ADDENDUM NO. 1

PROPOSAL FOR CONTRACT FOR
Miller Pond Edge Improvements
Doane College
Crete, Nebraska

Doane College Miller Pond Renovation
 Crete, NE
 TCEP Project No.: 439-042-11

Addendum #01
 Supplemental Drawing: SDI-001
 Revision of Sheet: L1.01
 Date: Aug. 13, 2012

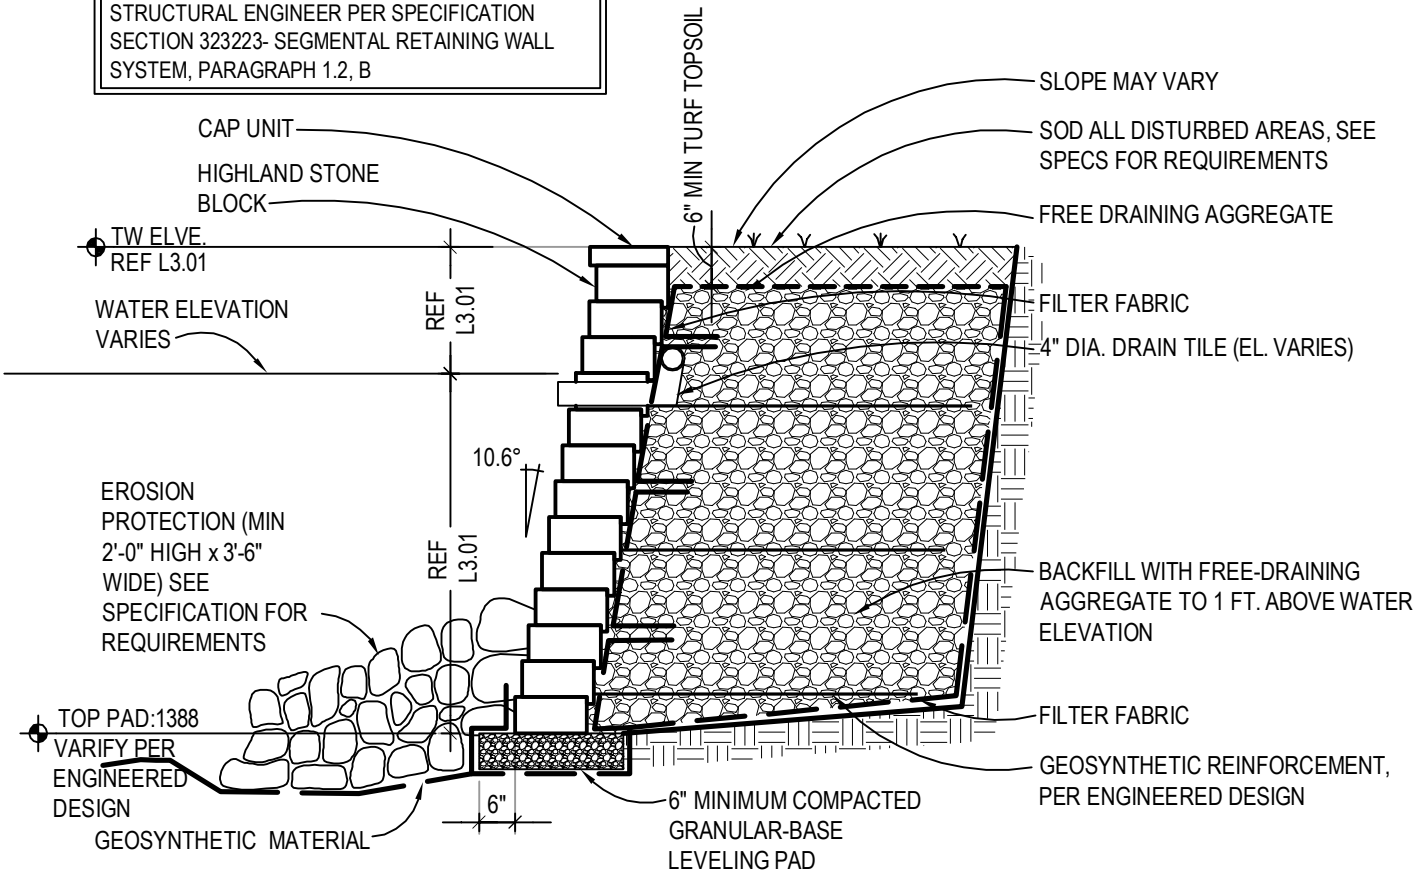
Refer to SDL-001 for additional tree removals

Addendum #01
Supplemental Drawing: SDL-002
Revision of Sheet: L2.01
Date: Aug. 13, 2012

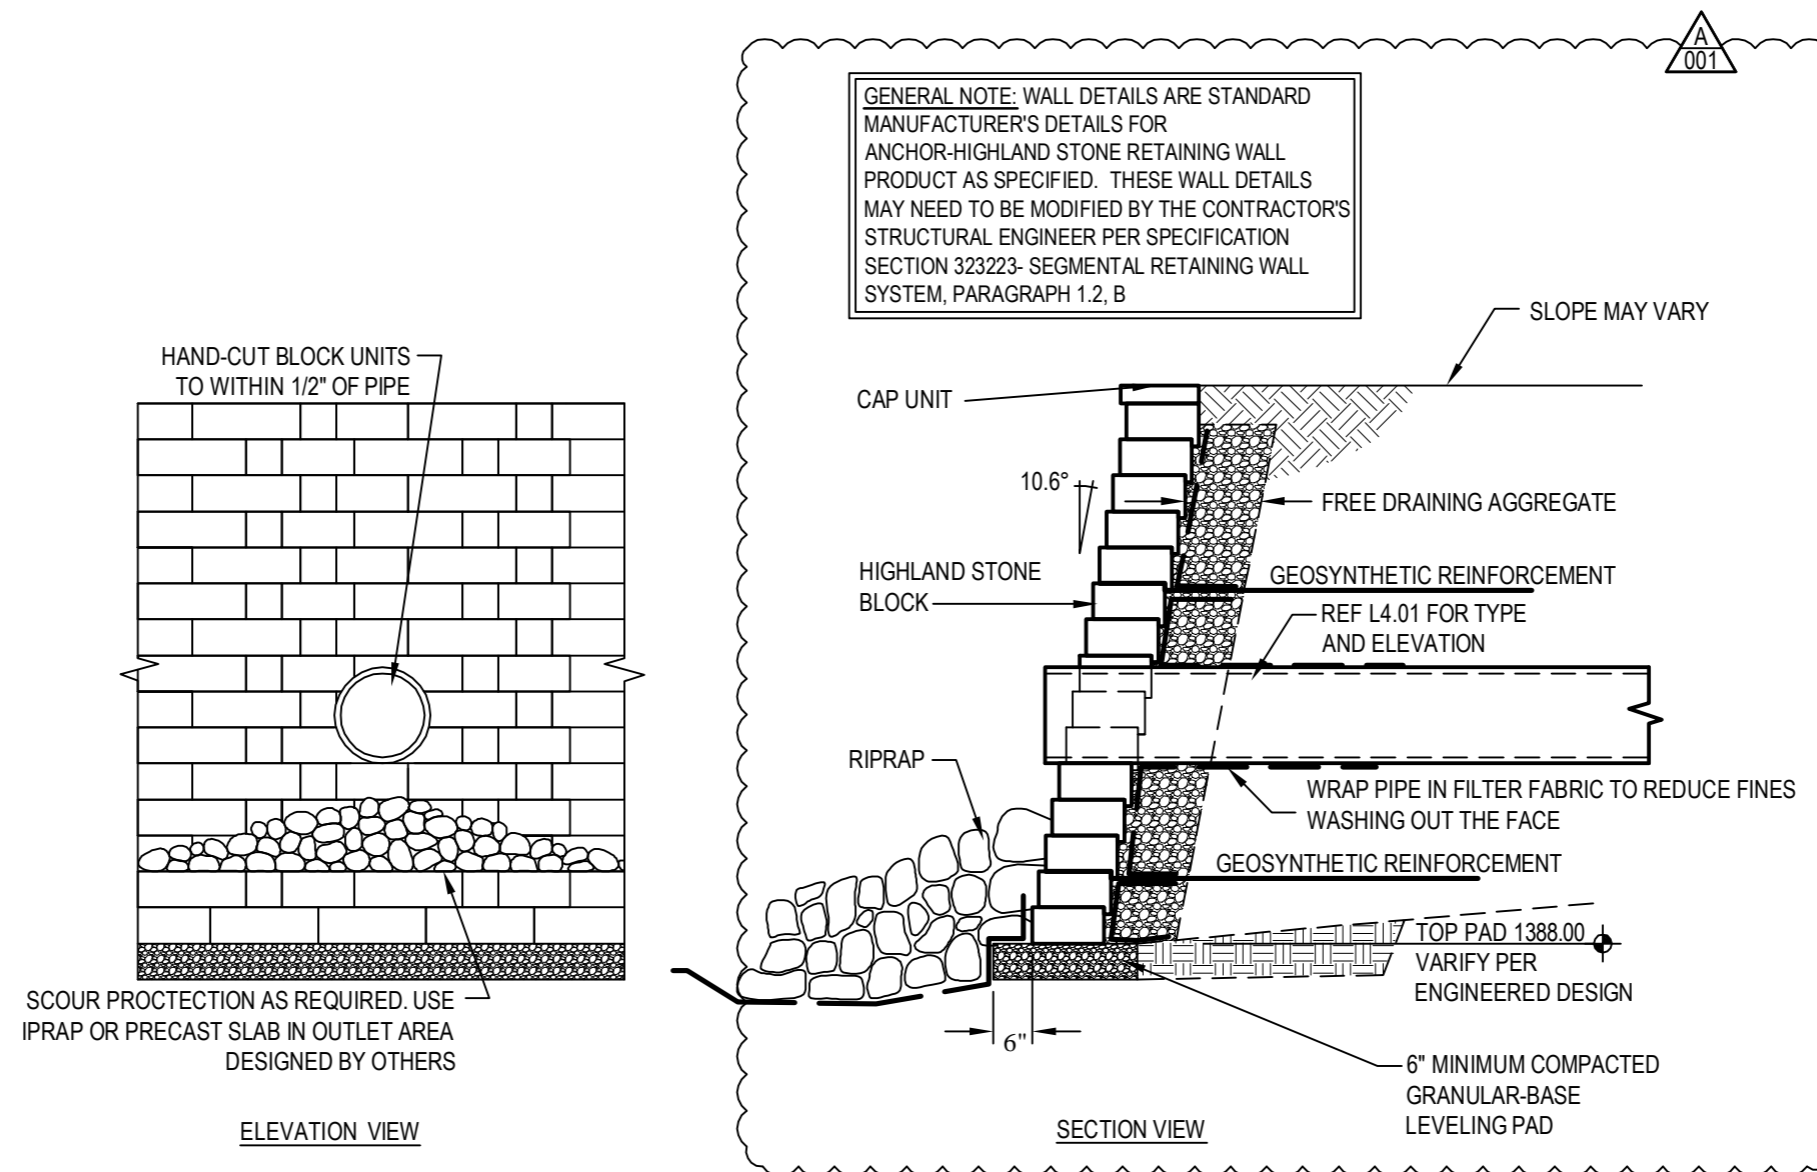
Refer to SDL-002 and SDL-003 for clarifications to standard wall details

GENERAL NOTE: WALL DETAILS ARE STANDARD MANUFACTURER'S DETAILS FOR ANCHOR-HIGHLAND STONE RETAINING WALL PRODUCT AS SPECIFIED. THESE WALL DETAILS MAY NEED TO BE MODIFIED BY THE CONTRACTOR'S STRUCTURAL ENGINEER PER SPECIFICATION SECTION 323223- SEGMENTAL RETAINING WALL SYSTEM, PARAGRAPH 1.2, B
